## Product Change Notice (PCN)

PCN Number: **PCN-0451204R-01**

Product(s) Affected: **PJ-057AH**

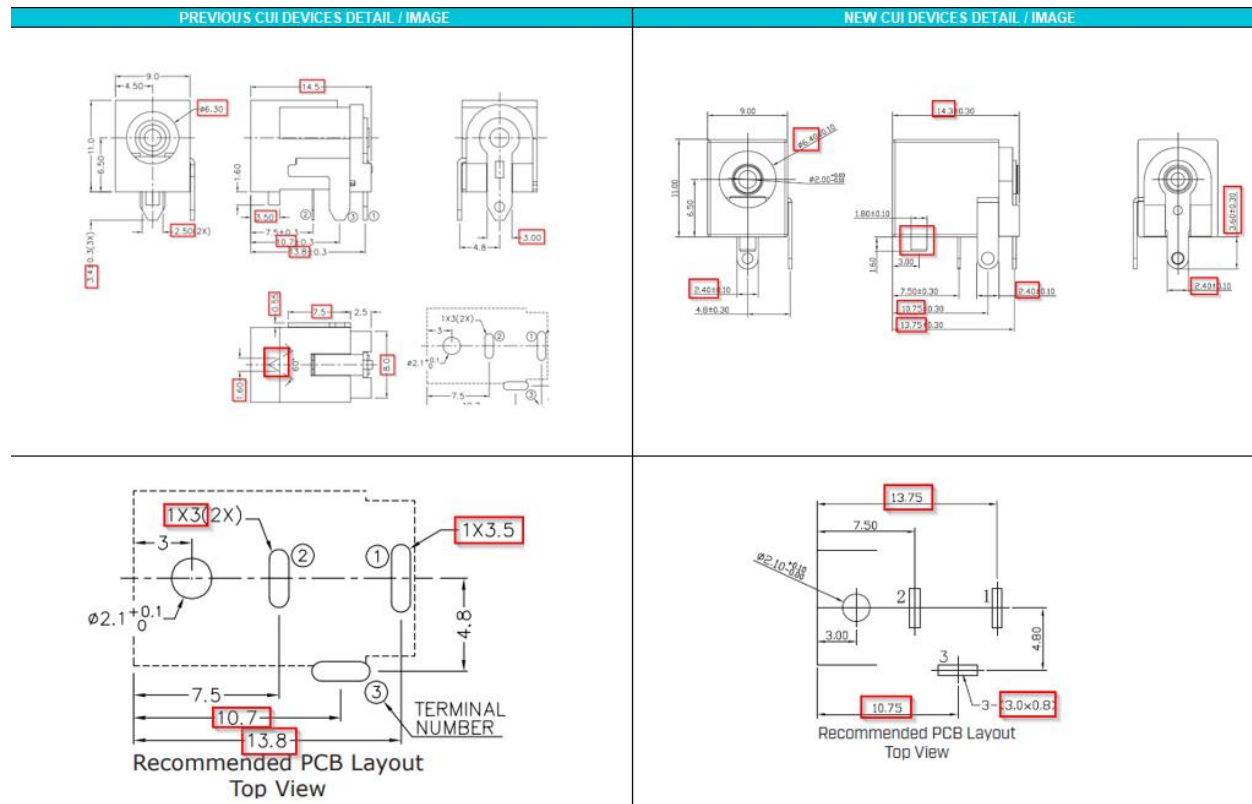
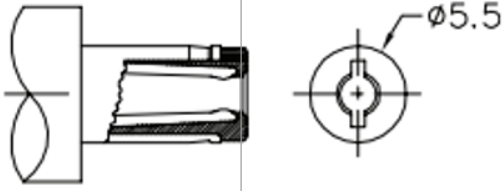
Description of Change: **Minor Housing and footprint differences. Material Change on the housing and terminals. See image Below**

PREVIOUS CUI DEVICE'S DETAIL / IMAGE			NEW CUI DEVICE'S DETAIL / IMAGE		
	MATERIAL	PLATING	DESCRIPTION	MATERIAL	PLATING/COLOR
center pin	copper	nickel	center pin	brass	nickel
terminal 1	brass	silver	terminal 1	brass t=0.40	silver
terminal 2	copper alloy	silver	terminal 2	bronze t=0.30	silver
terminal 3	brass	silver	terminal 3	brass t=0.40	silver
plastic	PBT		cover	PA10T (UL94V-0)	black
			housing	PA10T (UL94V-0)	black

**MATING PLUG**  
Jack Insertion Depth: **9.15 mm**

**MATING PLUG**  
Jack Insertion Depth: **9.45 mm**
